SUNNYSIDE VILLAGE

WICHITA, SEDGWICK COUNTY, KANSAS

RE: S/D 9892 -- One-Step Final Plat of SUNNYSIDE VILLAGE ADDITION

CASE NUMBER: S/D 98-92 - SUNNYSIDE VILLAGE ADDITION

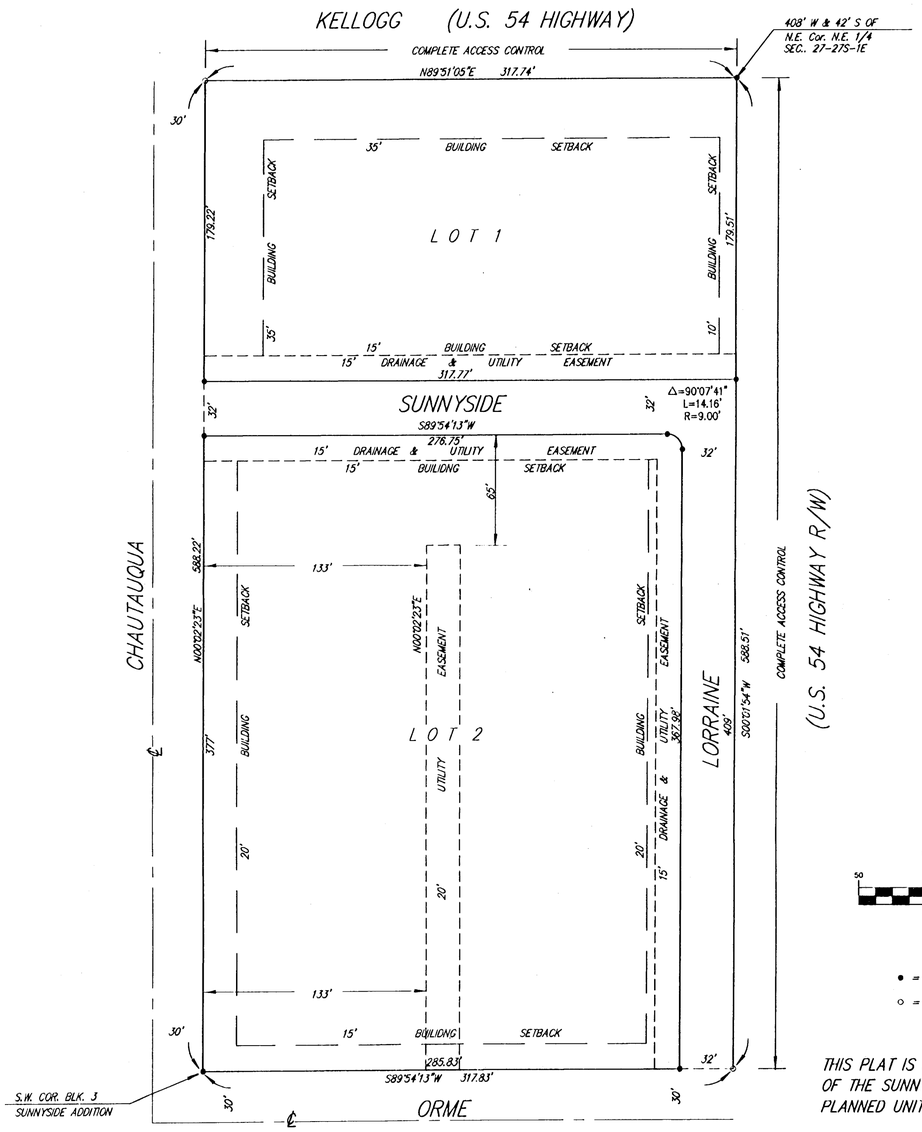
B. The Applicant shall guarantee the extension of City water and sanitary sewer to serve the lots being platted. City Engineering needs to verify if any other guarantees are required. ***To allow for a 15-ft drainage and utility easement adjacent to Sunnyside, the street will need to be relocated southward.***

F. Since this plat proposes the platting of narrow street right-of-way with adjacent "15-foot street drainage and utility easements", a restrictive covenant shall be submitted which calls out restrictions for lot-owner use of these easements. Retaining walls and change of grade shall be prohibited within these easements as well as fences, earth berms and mass plantings.

J. On the final plat tracing, a note shall be placed on the face of the plat indicating that this Addition is subject to the conditions of the Planned Unit Development, PUD #5.
